TECHNICAL MEMORANDUM

Date:	May 24, 2025
To:	Laura Baker, Friends of the Gualala River
From:	Greg Kamman, PG, CHG
Project:	24-1013 Technical Assistance to FOGR
Subject:	Conceptual BMP Recommendations to Caltrans Streetscape Project

FIGURE 4: Existing drainage alignments associated with the southern portion of the Streetscape Project.

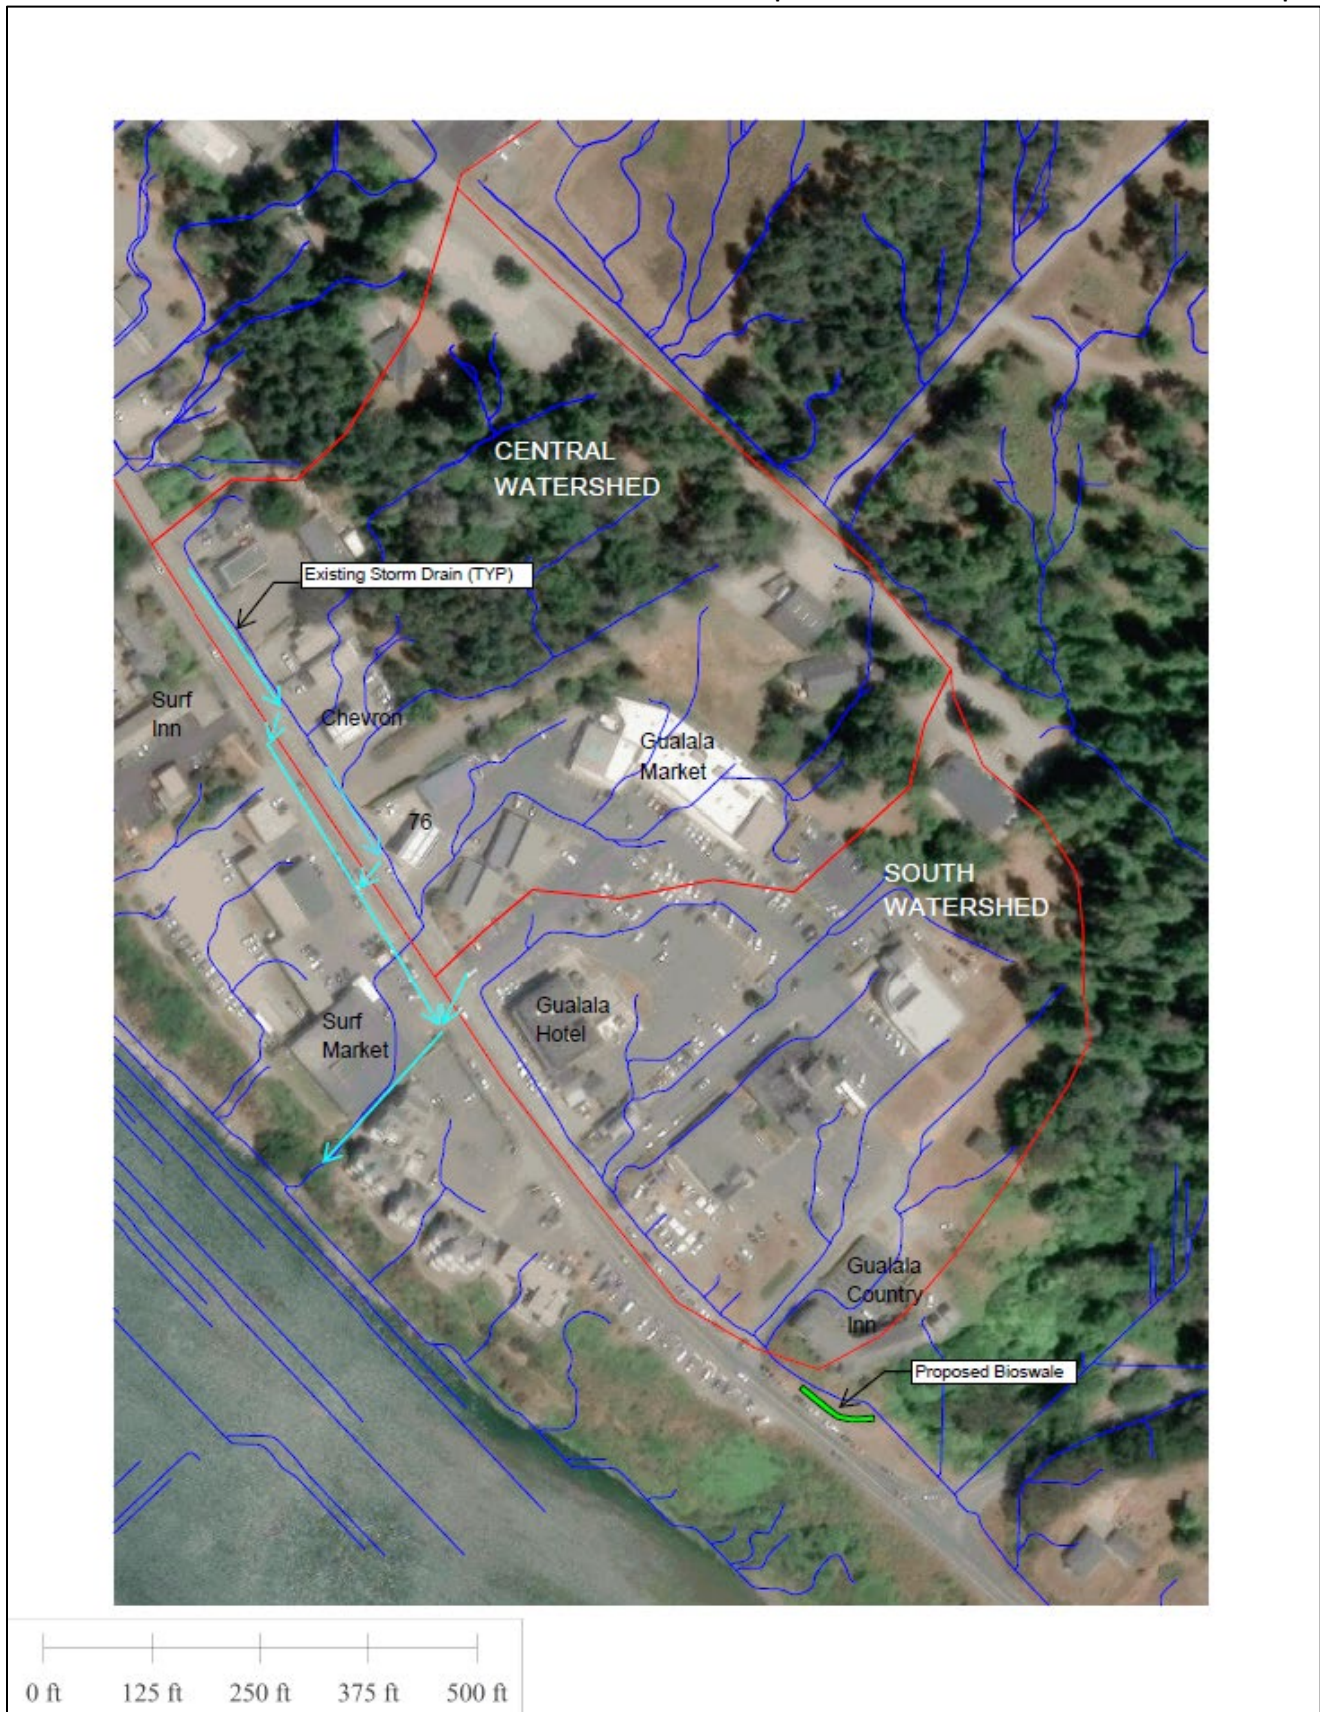
Figure 4 is a map focused on the Central and South Watershed drainage areas and pathways. It also indicates the proposed location of the Caltrans bioswale behind the Gualala Country Inn at the south end of the Project, which is intended to reduce pollutant loads from the Project. An important finding from this study is that the bioswale would only receive and treat runoff from only the South Watershed. However, as presented above, the elevated concentrations of 6PPD-q identified by The Stream Teams water quality monitoring program are sourced from the Central Watershed. There are no BMPs proposed in the Streetscape Project to treat runoff from the Central Watershed.

FIGURE 5: Conceptual BMP recommendations to the southern portion of the Streetscape Project.

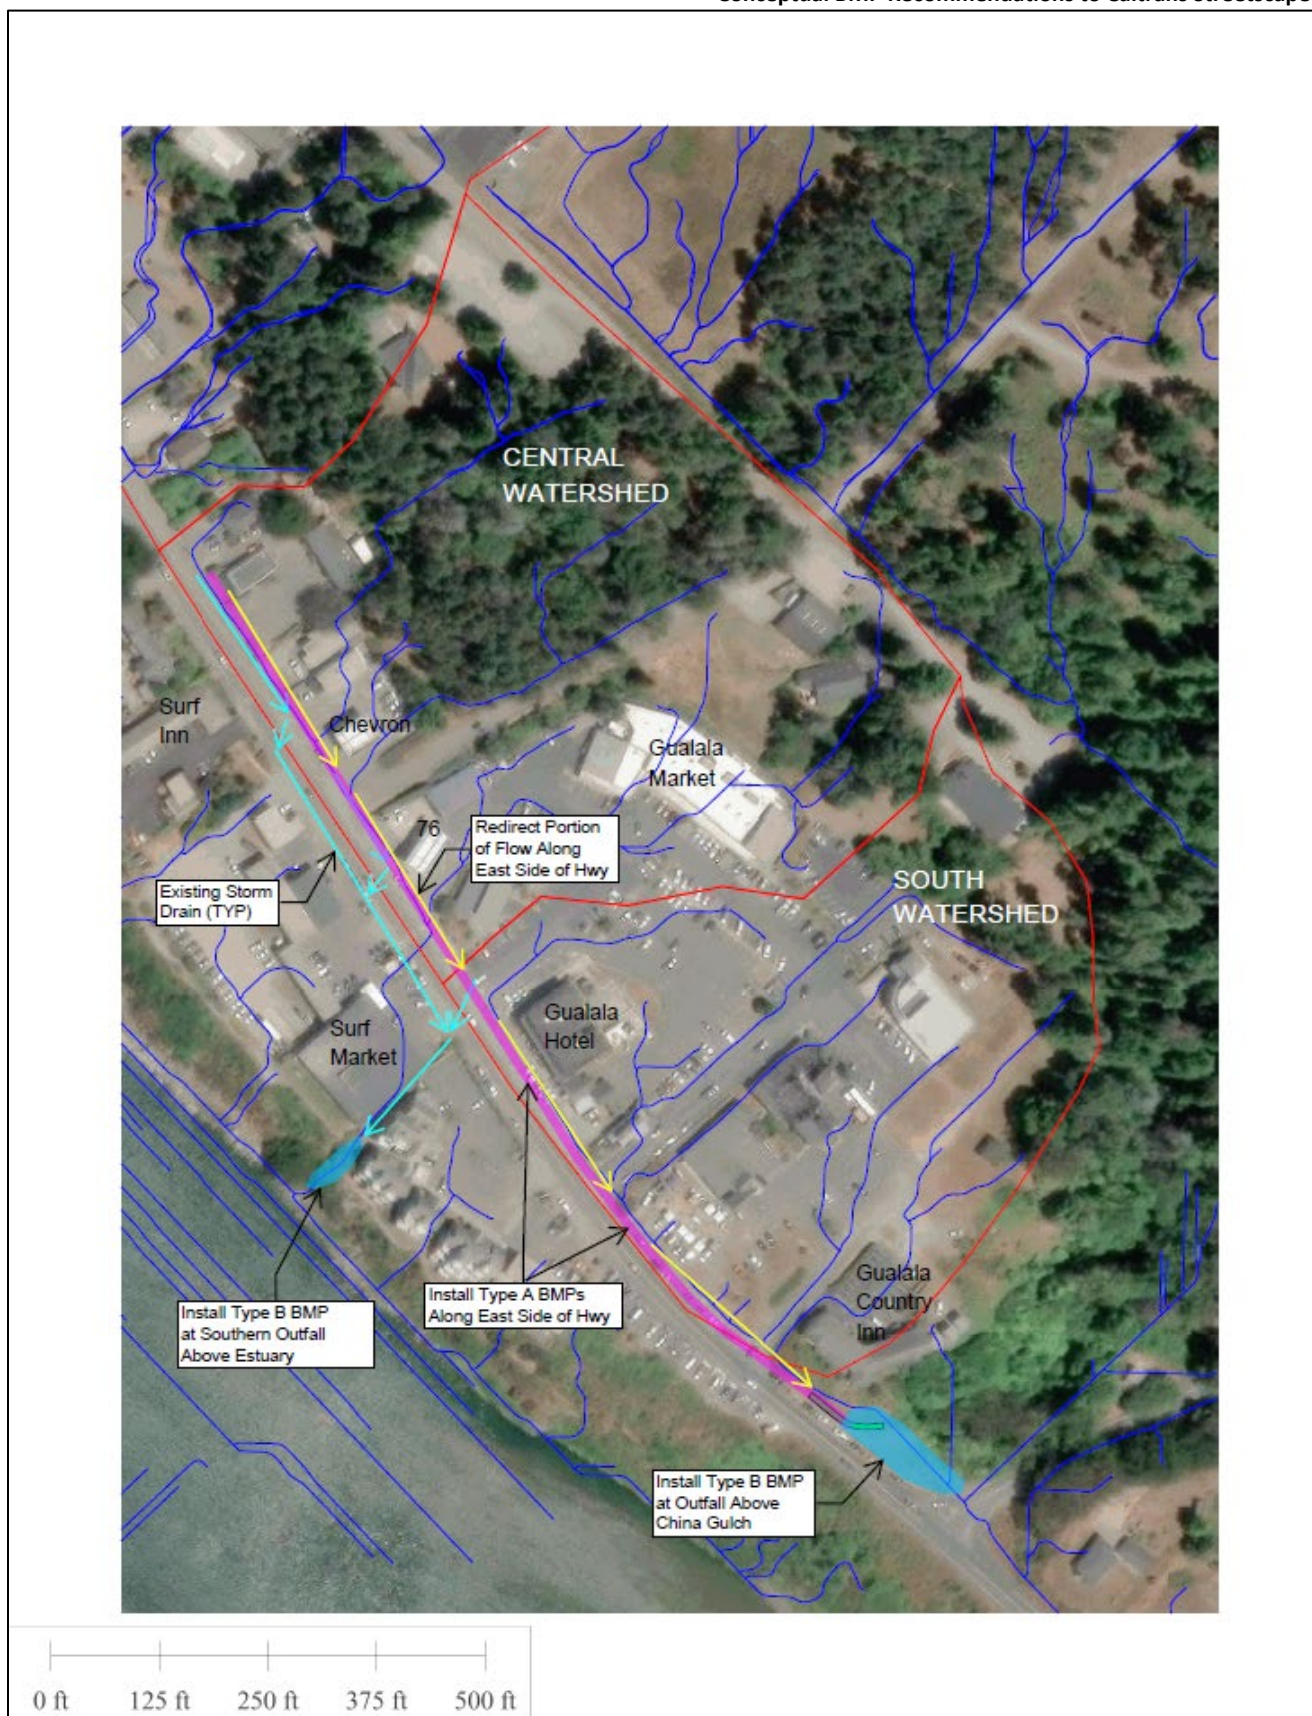
Based on these findings, cbec has identified conceptual BMP measures that could be incorporated or complement the Streetscape Project to reduce pollutant loadings to the estuary from the Central Watershed (see **Figure 5**). The assumptions and strategies behind these BMP measures follow.

Given Project right of way width constraints, the largest area that can accommodate additional or expanded BMPs is located within and beyond the proposed bioswale between the Gualala Country Inn and Old State Highway (**Figure 5**). This area would outfall into China Gulch Creek. The BMPs that could be incorporated into this area include an infiltration basin, bioretention basin, and/or bioswale (hereafter referred to as Type B BMPs).

The main goal of this conceptual BMP plan is to treat runoff from the Central Watershed. There probably isn't enough room to install an infiltration- or retention-basin in the southern outfall to the estuary (behind the Surf Market) that can handle/treat all the runoff from the Central Watershed. Thus, the existing Project underground storm drain system could be modified to reduce the amount of water directed from east to west across State Route 1 and into the southern outfall. This could be done by segregating flows and directing them through a series of linear BMPs along the east side of State Route 1 down to the Type B BMPs at the China Gulch Creek outfall. Examples of linear BMPs (referred to as Type A BMPs on **Figure 5**) that could be constructed along the east side of State Route 1 include: Design Pollution Prevention Infiltration Areas (DPPIA); infiltration basins; infiltration trenches; biofiltration strips/swales; and media filters (Caltrans, 2023). In addition, by reducing the amount of runoff directed to the southern outfall above the estuary, there may be sufficient room to install Type B BMPs at this location.
